NYBERG RIVERS

SW NYBERG ROAD
TUALATIN, OREGON

GENERAL INTRODUCTION TO ARB ADDENDUM # 1 PACKAGE

ARB ADDENDUM # 1 PACKAGE: 12/9/13
(IN RESPONSE TO 12/3/13 TUALATIN ARB HEARING)

Entrance Corridor

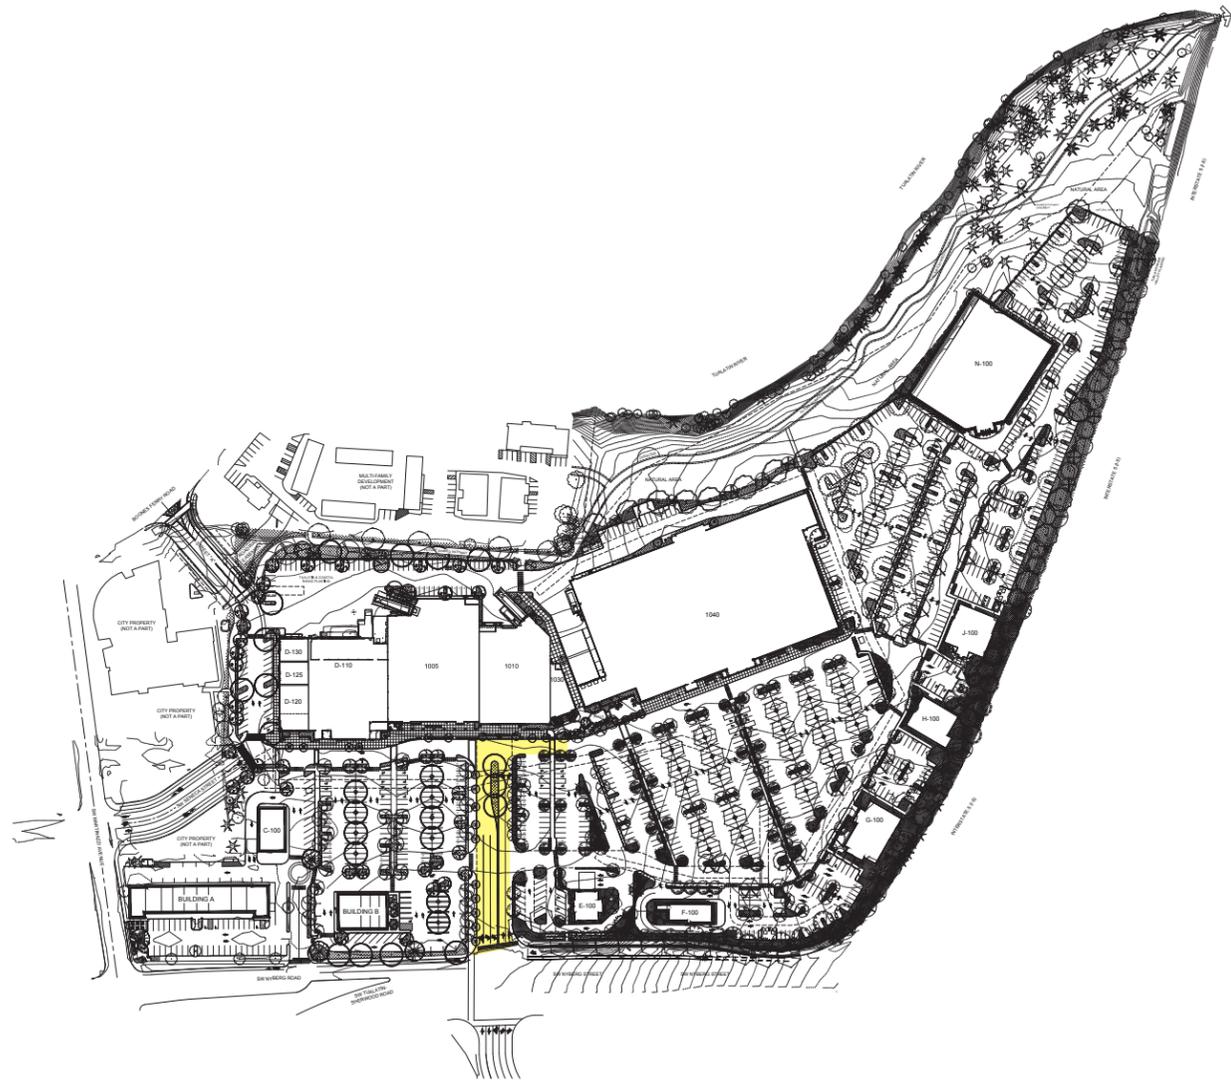
A central island within the roadway is planted with a mixture of shade trees and shrubs designed to provide a mixture of vertical elements that create visual interest. Options for expanding this central island were examined, however it was determined that the current design maximizes the allowable landscape area. Kittelson and Associates has provided the attached memo (see page 10.4) detailing the stacking needs of the center.

CenterCal has added additional landscaping along the corridor, including an additional row of trees planted in tree wells along the 14-foot wide shared pathway that runs along the west of the entrance. These trees provide additional vertical elements that delineate the corridor and insulate the shared pathway while also providing additional shade canopy over the roadway. The shared pathway terminates at an enhanced pedestrian and bicycle crossing that is textured and distinct from the paved vehicle travel lane providing pedestrian, bicyclists and motorist a distinct visual cue that delineates where the crossing is. The corridor and associated landscape plantings are shown in detail on Landscape Plan sheet L1.2 included within Exhibit O of the submittal.

Home Goods South Facade

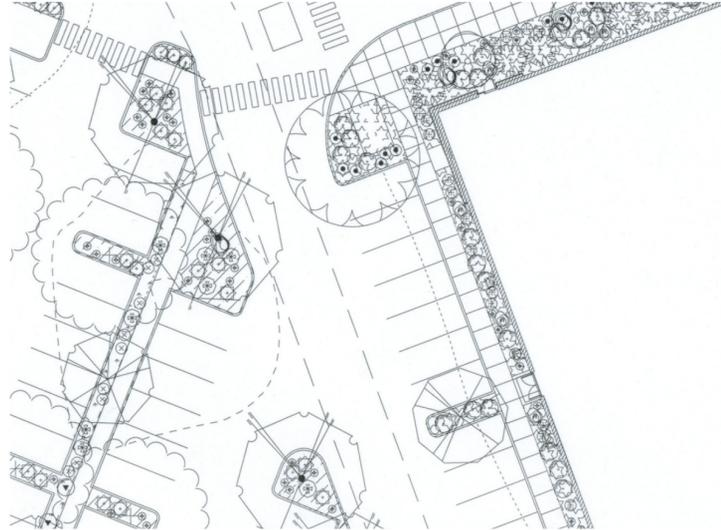
In response to ARB concerns, the Home Goods south facade has received additional design articulation to eliminate the “flattened” elevation mass. Please see the narrative on page 3.0 for additional information.

With respect to Home Goods south elevation, and in response to ARB concerns, the south entry portal tower has been articulated with a standing seam metal roof (similar to the future east restaurant) as a way to mitigate the long "flattened" elevation mass. The white band has been replaced with brick veneer, creating further articulation. The entry portal cornice height remains in proportion with Michaels to the west, contributing to the overall facade height variation. We feel this represents the articulation requested by the ARB while still maintaining the Home Goods strong visual brand experience.

ARB SITE PLAN 5' SIDEWALK (TYPICAL)

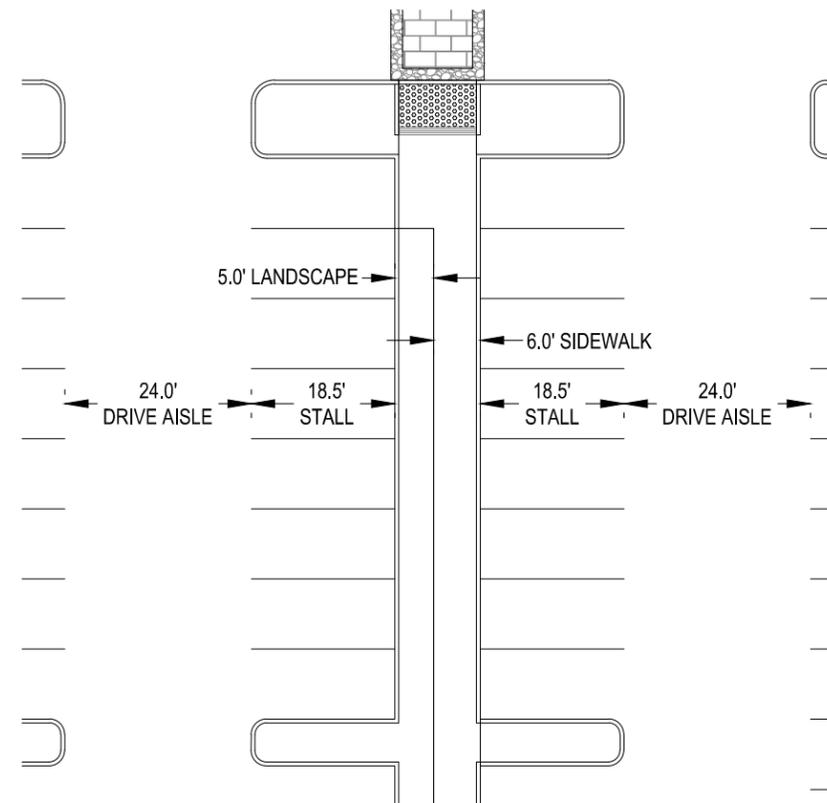
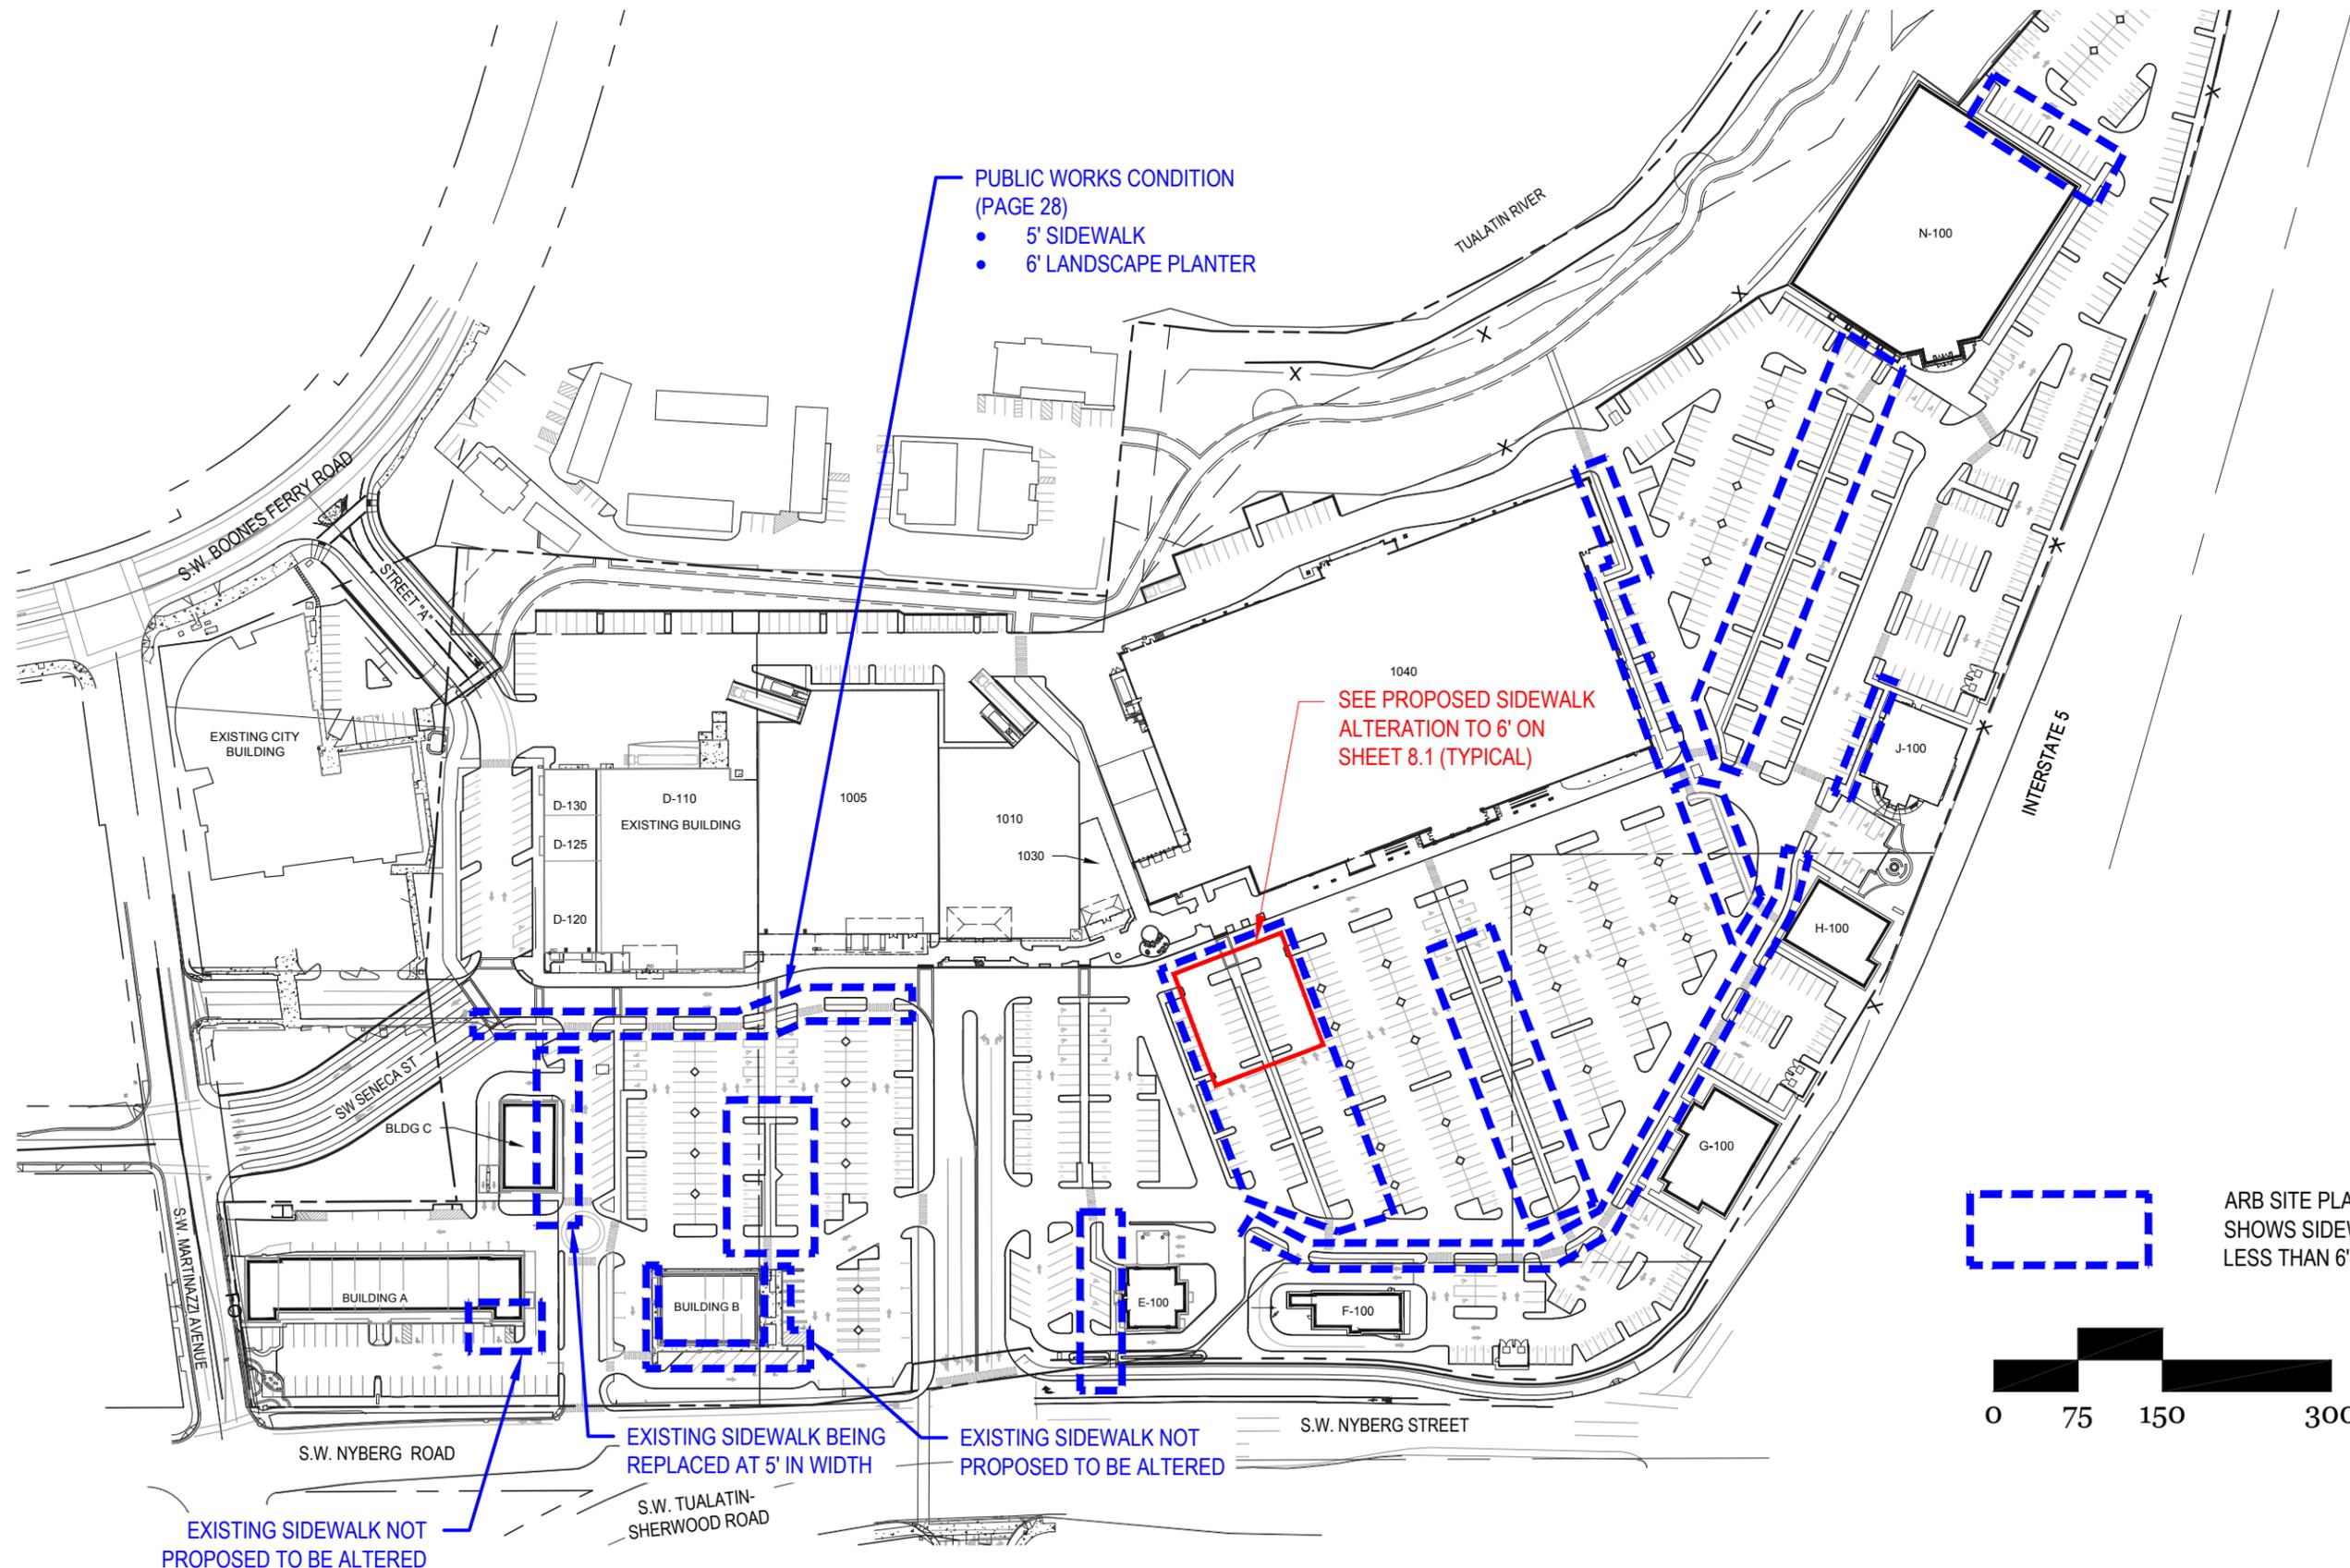
The Applicant understands the proposed condition of approval concerning six foot wide sidewalks and will redesign the parking fields to accommodate this request. A typical detail on how this will be accomplished is shown to the left/right. The site is comprised of existing development that will be enhanced with new buildings and amenities. Portions of the site that currently exist with 5 foot wide sidewalks that are not proposed to be altered include the frontage of building A and adjacent Banner Bank, there is also a conflicting public works condition for the "loop road" that calls for a 6' landscape and 5' walk. These areas are clearly identified within the attached exhibit.

ALTERNATION TO 6' SIDEWALK (TYPICAL)

TYPICAL RETAINING WALL (SEE CIVIL PLANS FOR ALL LOCATIONS)

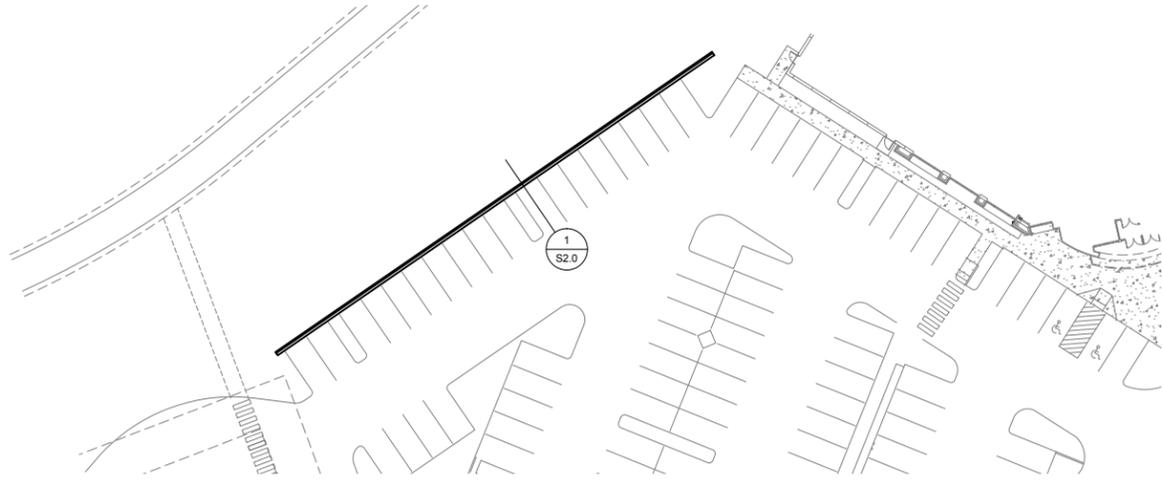
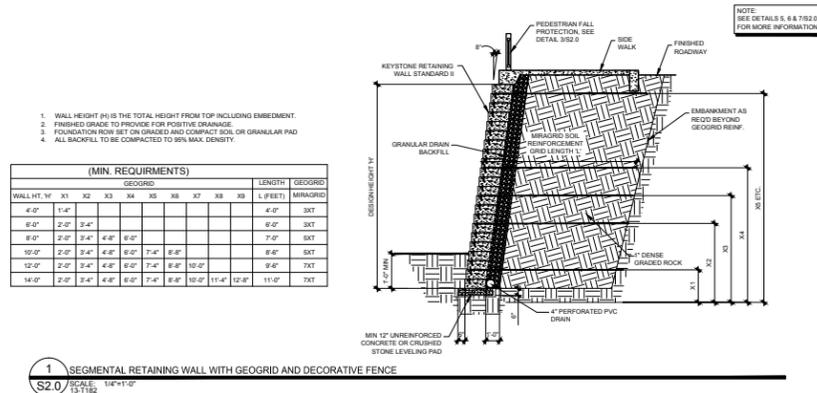
Because the project is a redevelopment of an existing center that expands into new areas it was difficult to design and grade the site to work with existing grades, address stormwater concerns, accommodate ADA requirements, and balance the cut and fill. As a result some area of the site necessitate retaining walls. Attached is an exhibit that details where the walls are required, how high they are and how they are proposed to be constructed. The walls on the north side of the site are keystone retaining walls with fall protection fencing on top. The proposed wall south of the Nyberg Street improvements is a cast-in-place wall. This will be constructed in the final ODOT ROW and will be permitted through ODOT. The walls are also shown in more detail on Sheets C3.0 through C3.2 of Exhibit O.

ROOT ZONE CROSS SECTION

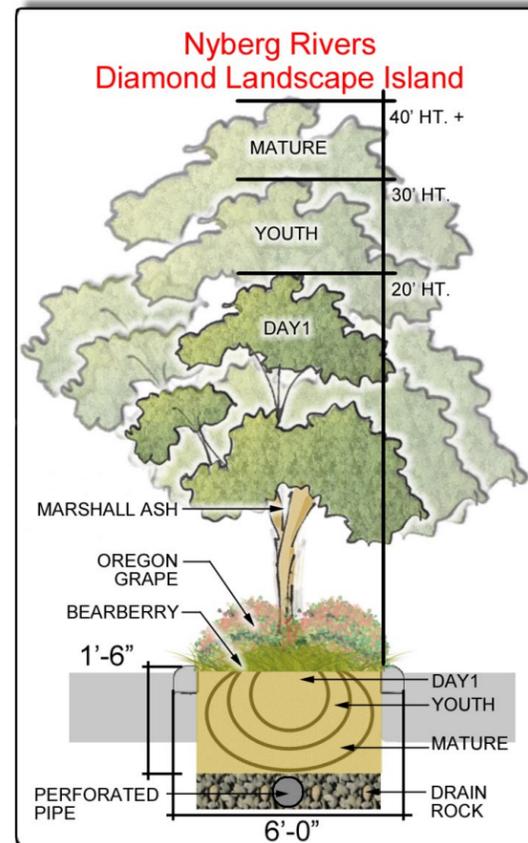
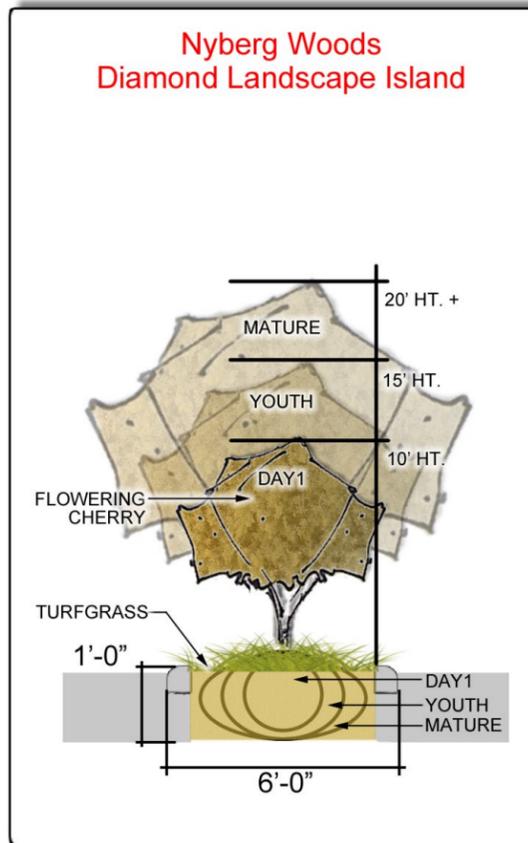
The Nyberg Rivers Site Plan illustrates a similar approach to landscape in the parking lot's diamond planters, with some major enhancements compared to the design at Nyberg Woods. The City of Tualatin requires under TDC Section 73.360(1) that a landscape planter island area shall be 'a minimum of 25 square feet'...'shall be protected by curbs'...'dispersed throughout the parking area'...'and planted with a tree that meets the parking lot shade tree requirements' outlined in 73.360(7) above. Twenty-five square feet plus the 6" curb equals a planter well with an outside dimension of 6'x6'. No soil depth is required under the code. The planter diamonds at Nyberg Rivers will meet the required inside dimensions of 5'x5' with a design depth of 18". This area measures 25 sf with a volume of 37.5cf. An additional gravel storage layer below the soil will measure 5'x5'x9", adding 18.75cf. This pipe network will be connected to the parking lot storm system to improve planter drainage. The total volume of soil and drainage system for the root zone of each tree in the improved planter is 56.25cf. The perforated pipe installed at the bottom of each planter pit within the gravel storage layer will improve soil drainage and provide additional room for deeper root growth. Shallow surface rooting and heaving pavement will not be a lingering concern, and the tendency for 'bathtubs' during the winter months will be

eliminated. The improved design ensures that trees do not sit in stagnant soils and have ample room to anchor and establish themselves. (Refer to Sheet 10.0)
